**Town of Kittery  
Planning Board Meeting  
October 13, 2022**

**ITEM 3 – 41 Route 236 – Preliminary Site Plan Review**

**RE: Town of Kittery, Planning Board Services  
Preliminary Site Plan Review  
Well Field 44 Cannabis Dispensary, 41 Route 236, Tax Map 29, Lot 1  
CMA #591.150**

TAX MAP 29, LOT 1  
 STORMWATER: EXPANDED DEVELOPED CONDITIONS  
 WELL FIELD 44 CANNABIS DISPENSARY  
 41 ROUTE 236, KITTERY, ME 03904

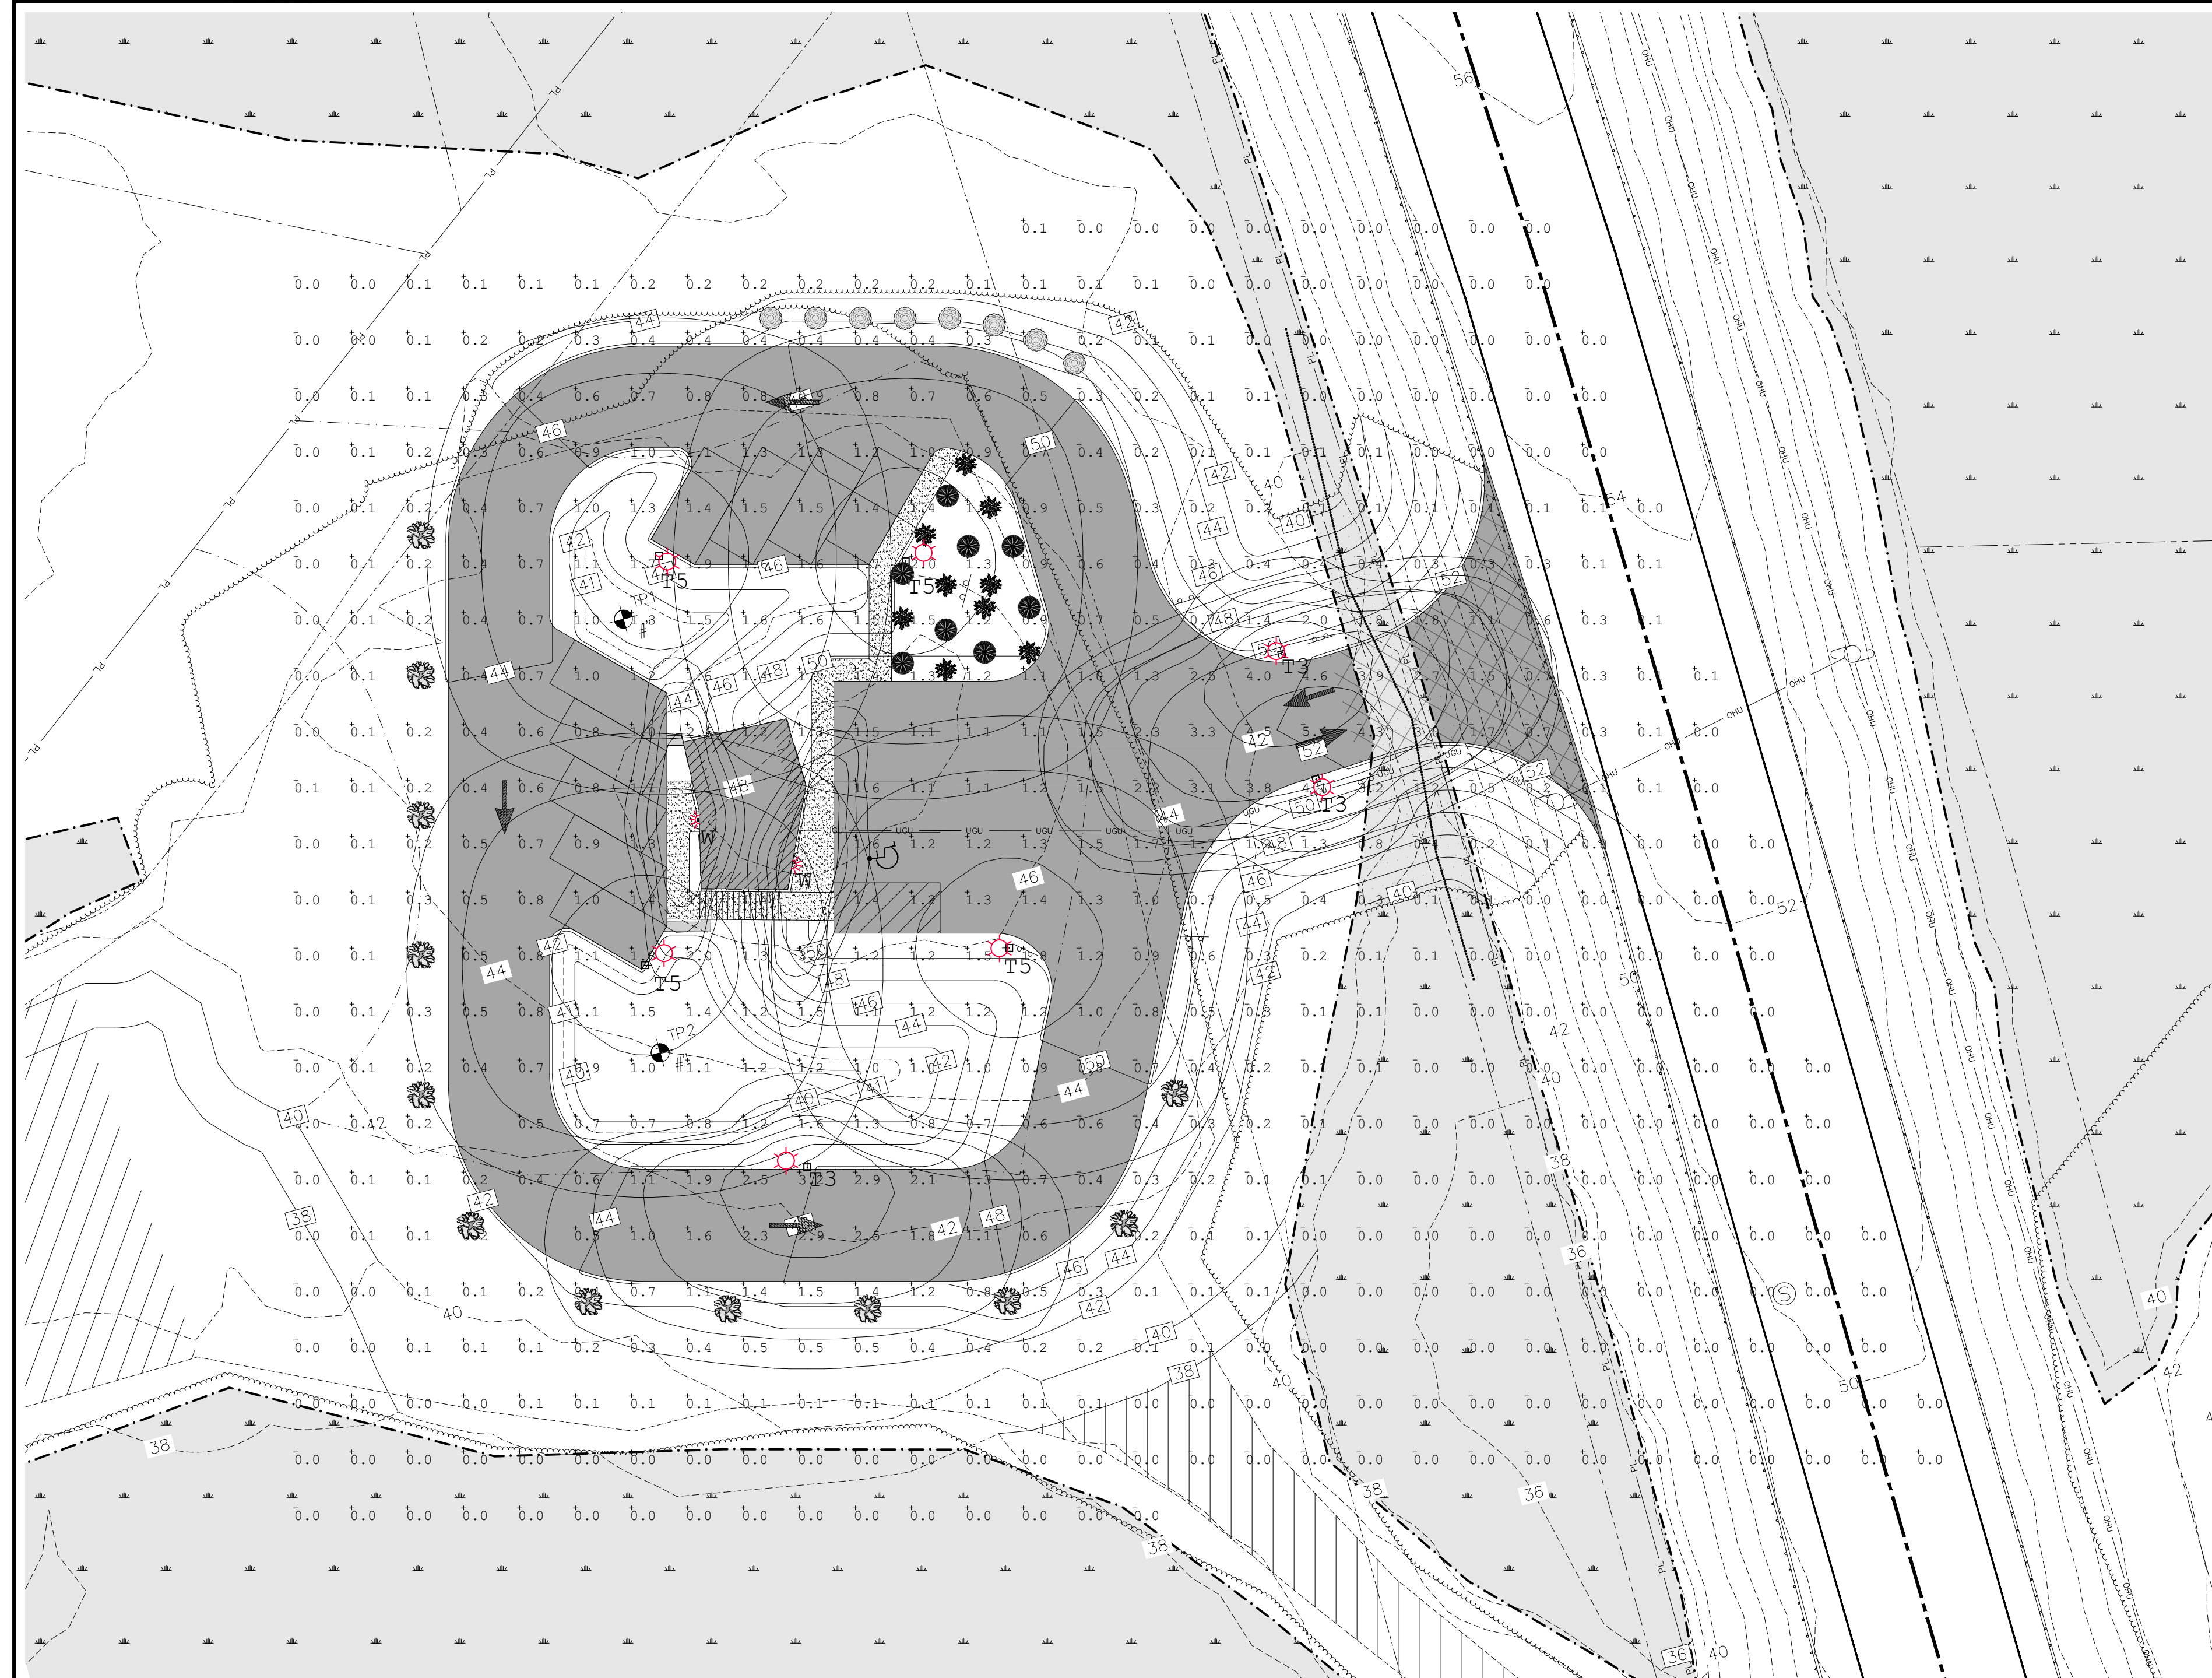
Sheet 8-Stormwater: Expanded Developed Conditions:

- The inverts, size, slope, and pipe material of the downstream culvert on Manson Road should be shown on the plan.

LANDSCAPING PLAN  
WELL FIELD 44 CANNABIS DISPENSARY  
41 ROUTE 236, KITTERY, ME 03904

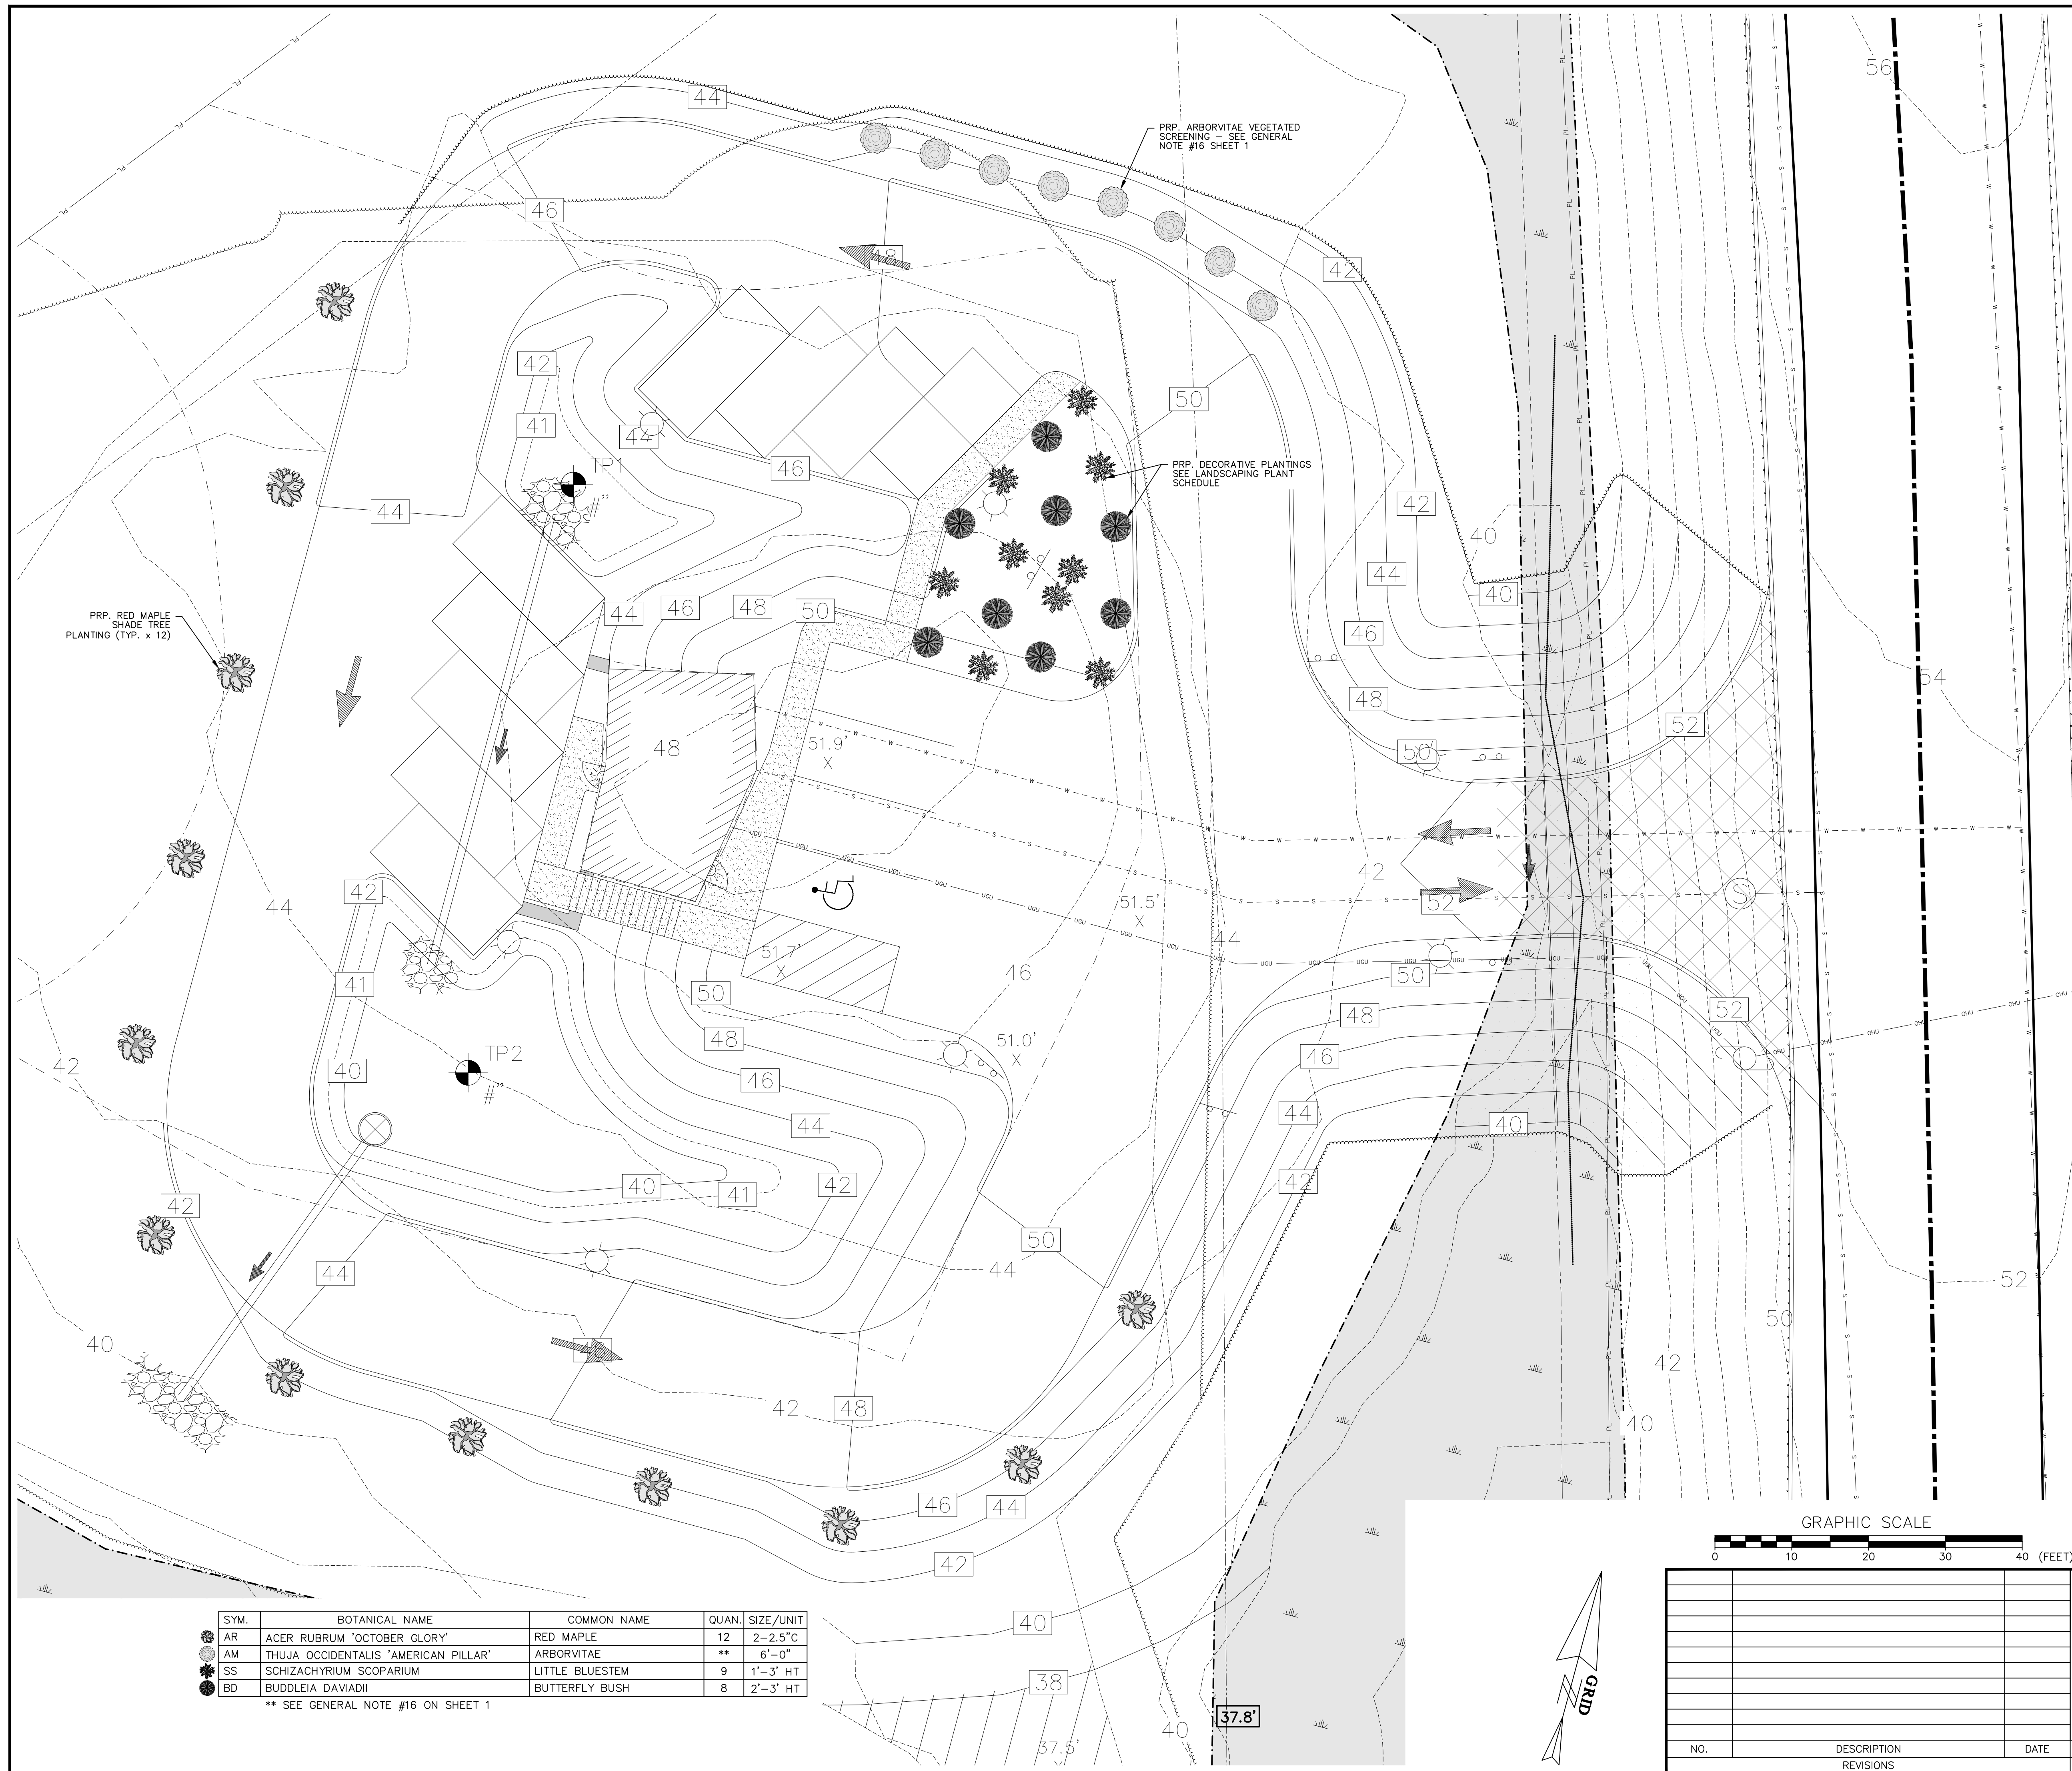
Sheet 10-Landscaping Plan:

- Provide planting details for the shrubs and trees.
- The plan should include notes on planting, plant maintenance, mulching, etc.
- The number of arborvitae and/or other screening plants should be specified on this plan and not determined per General Note 16 on Sheet 1 after construction.
